LETTER OF TRANSMITTAL

SUBJ: Drainage Plan for Blanchat Machine Addition

DRAINAGE PLAN FOR BLANCHAT MACHINE COMPANY ADDITION **N.W.1/4, S. 25, T.27S., R.1W. OF THE 6TH P.M.** **WICHITA, SEDGWICK COUNTY, KS**

DRAINAGE PLAN FOR BLANCHAT MACHINE COMPANY ADDITION 3323 MAPLE, WICHITA, KS		
PROJ. NO.: CERTIFIED ENGINEERING DESIGN		
438 NORTH OHIO WICHITA, KANSAS 67214 (316) 262-8808		
DESIGNED: HDF	SCALE: 1" = 40'	SHEET 1
DRAWN: TILS, HDF	DATE: 6-1-98	
CHECKED: HDF	FILE: BLANCHAT.DWG	TOTAL 1

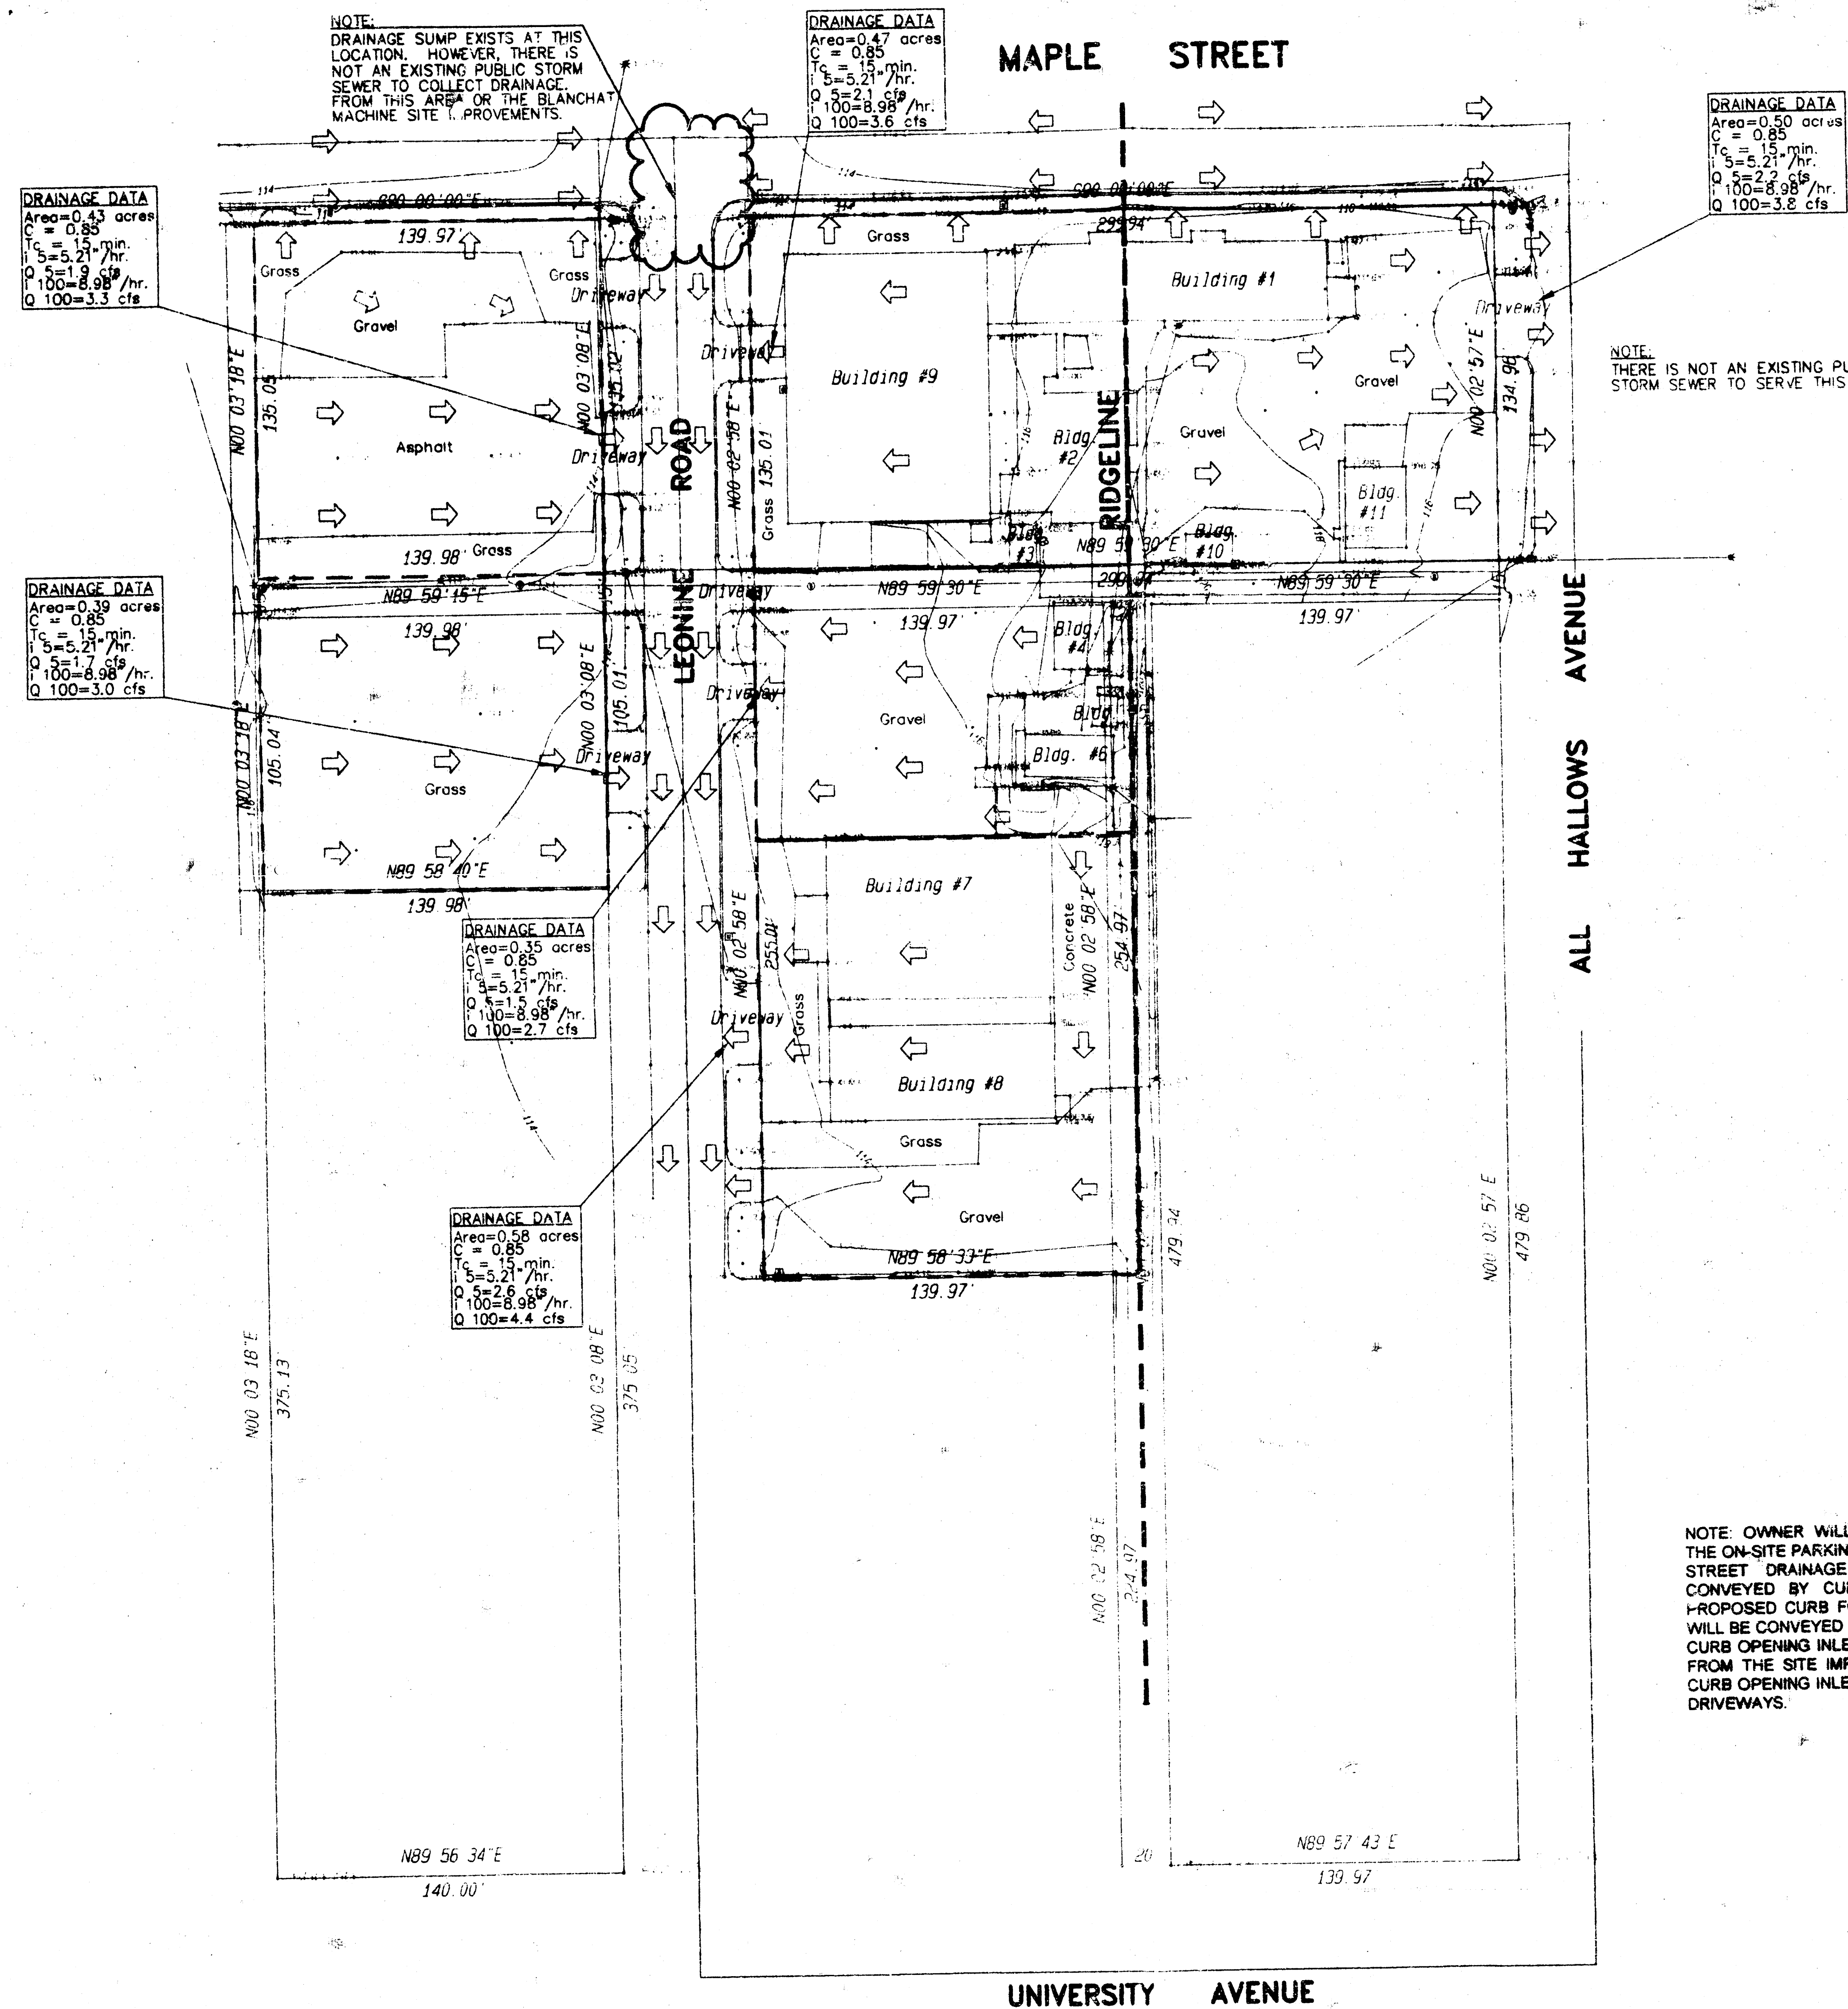
COMMENTS: Attached find the revised drainage plan for the above referenced addition. A note has been added to the drainage plan requiring on-site parking lot detention will be required when the site improvements are constructed.

NOTE: OWNER WILL IMPLEMENT DETENTION STORAGE INTO THE ON-SITE PARKING LOTS AND WILL RESTRICT FLOW TO THE STREET DRAINAGE SYSTEM TO THAT WHICH WILL BE CONVEYED BY CURB OPENING INLETS LOCATED IN THE PROPOSED CURB FOR THE ON-SITE PARKING LOT. RUNOFF WILL BE CONVEYED TO THE STREET CURB VIA 6" PVC PIPE AND CURB OPENING INLETS IN THE STREET CURB. THE DRAINAGE FROM THE SITE IMPROVEMENTS WILL BE DIRECTED TO THE CURB OPENING INLETS AND WILL NOT BE CONVEYED OUT THE DRIVEWAYS.
